Confirmation for Testing & Pre-lin Plan

Subject: Percolation Certification Revised Plan
1723 Underwood: Tax Map: 9 Parcel 300

SEPTIC FIELD LAYOUT

1723 UNDERWOOD ROAD
SEPTIC SYSTEM

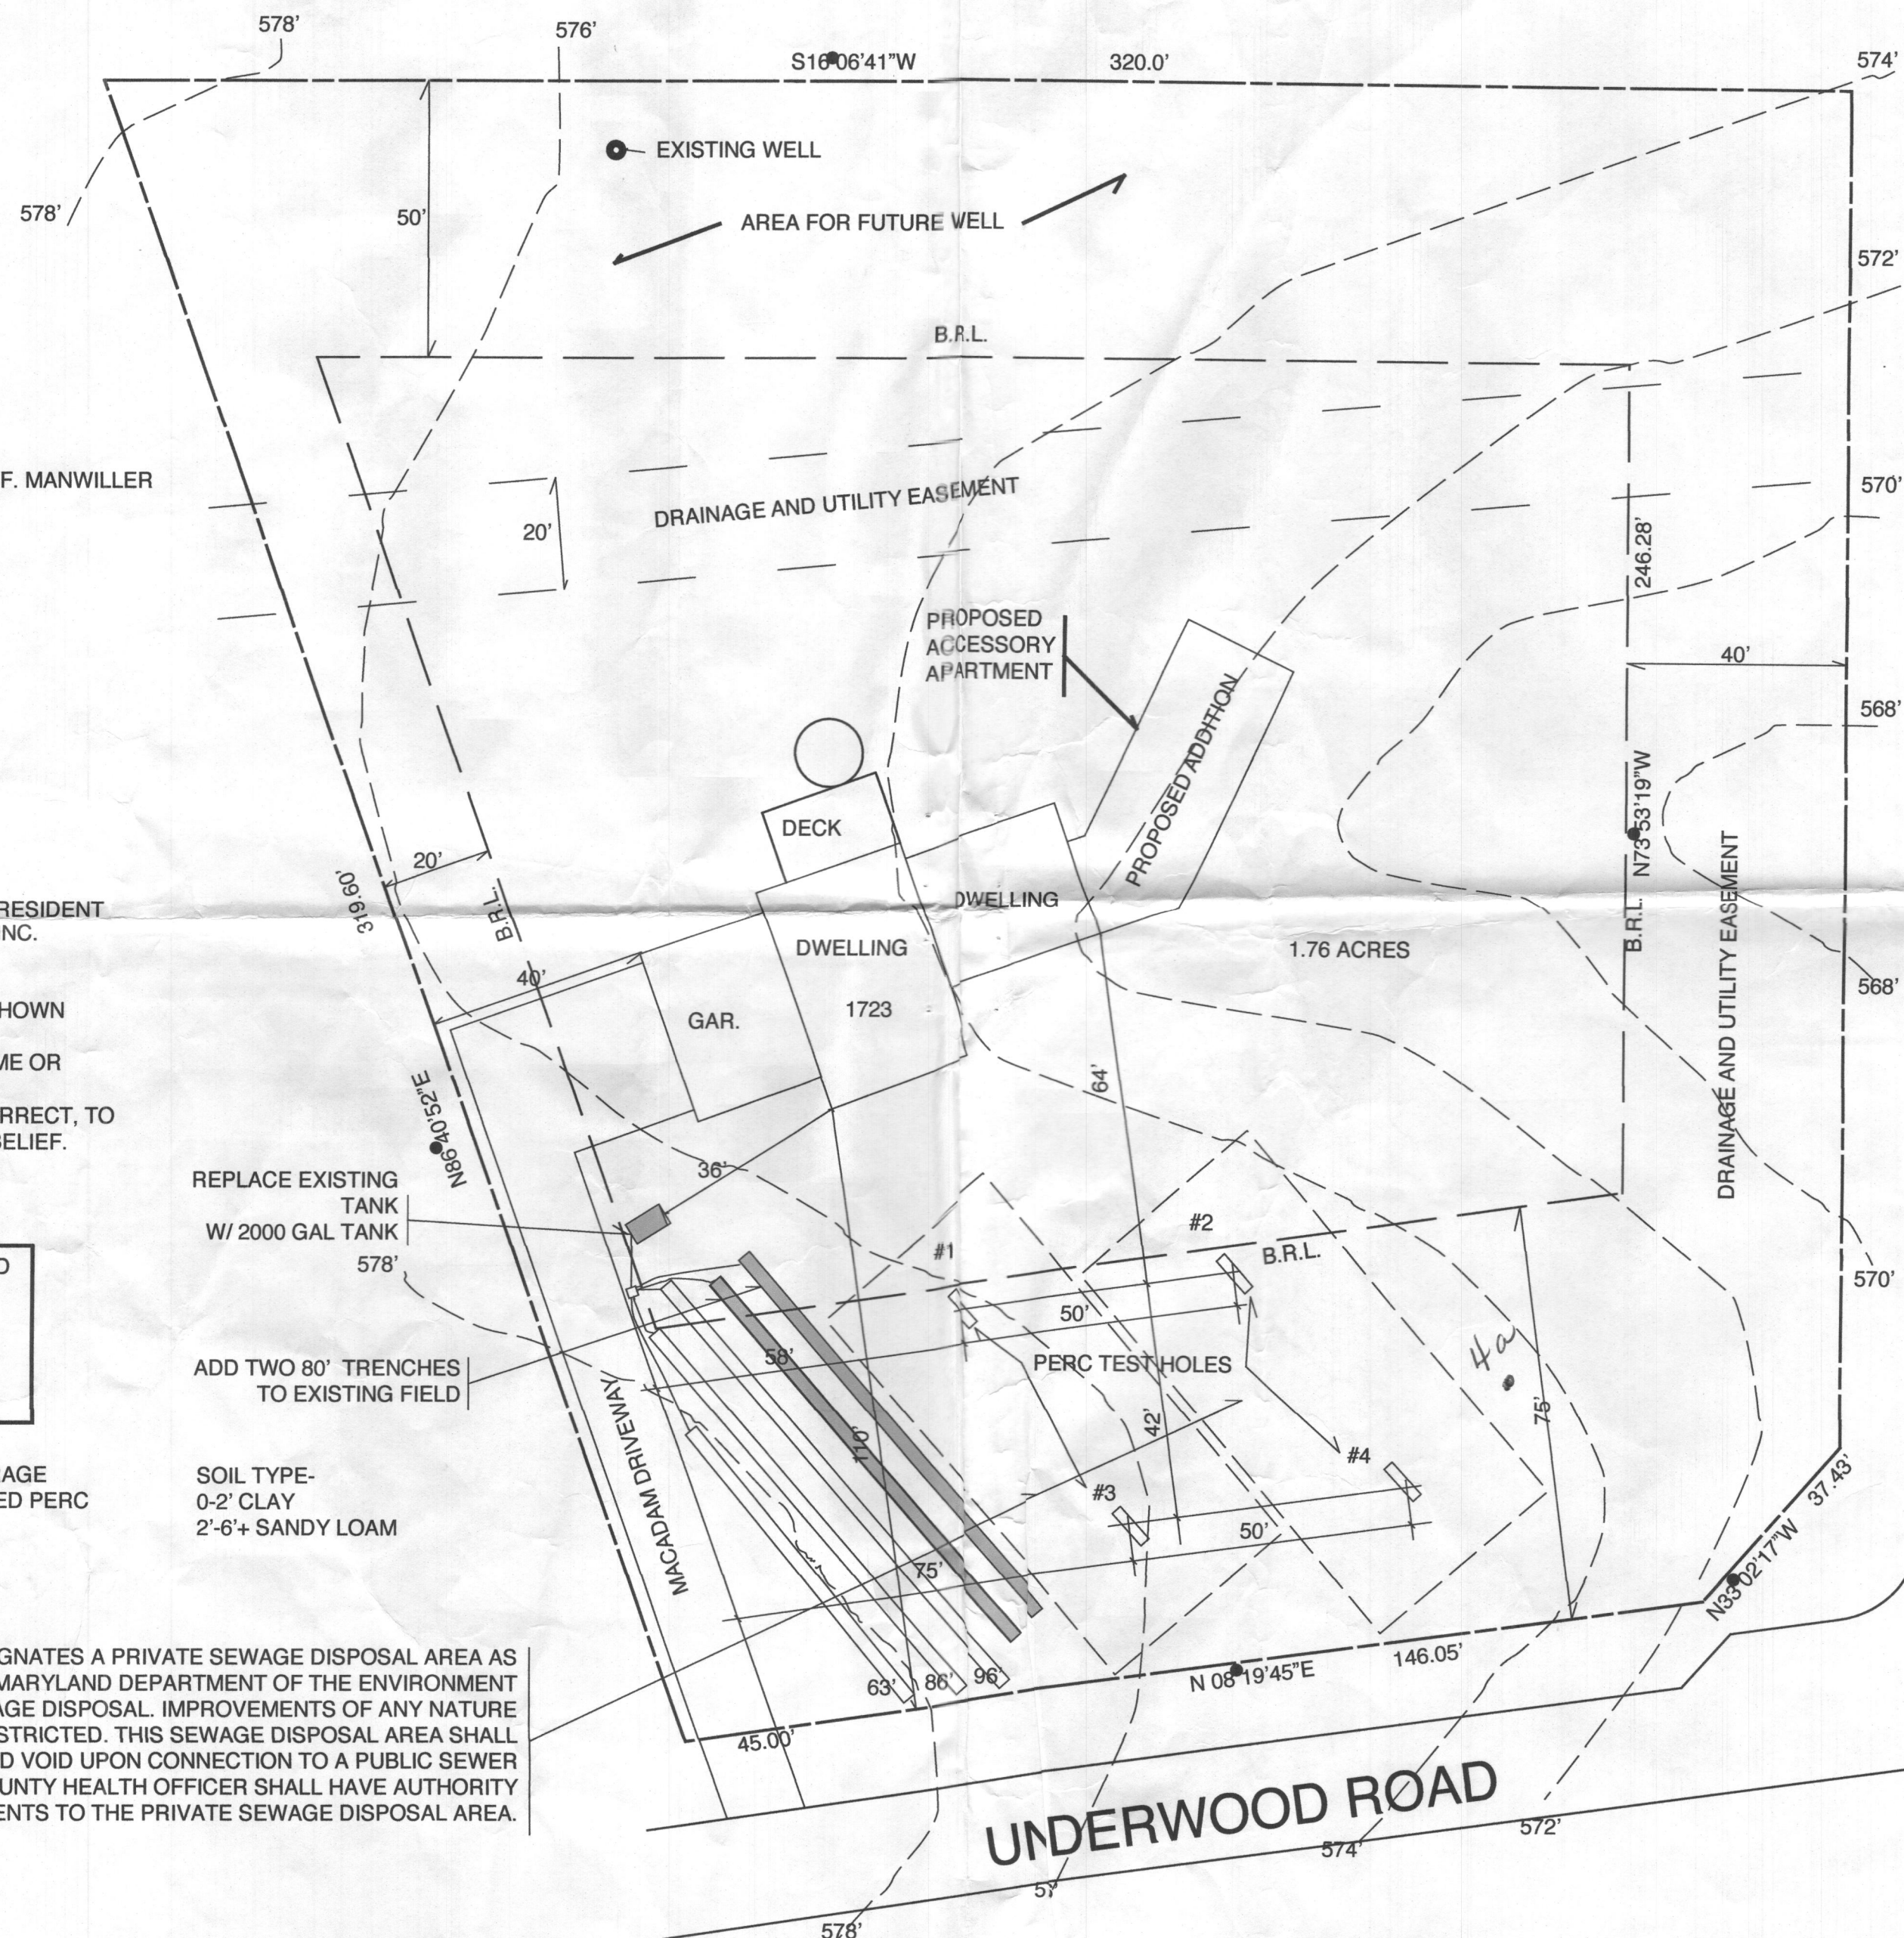
I explained that the original 10,000 sq ft area was compromised by the house and we had failing holes in 1994 and ~~2022~~ ²⁰²¹ complicating the attempt to revise the area and maintain 10,000. We also have the issue of neighboring well downgrade. They said test hole locations came from surveyor hired by ~~engineer~~ ^{builder}. I told them we need field captured test hole locations shown on plan. Once I have that, we can see what area is available for SDA. We will likely be less than 10,000, but I'm hopeful we can have enough area above failing holes to fit 2 future systems at 5 bedrooms. This area is also close to 300' from neighboring well to avoid BAT unit now. May need note for future BAT.

I also explained why we need topo extending beyond property line and replacement well sites.
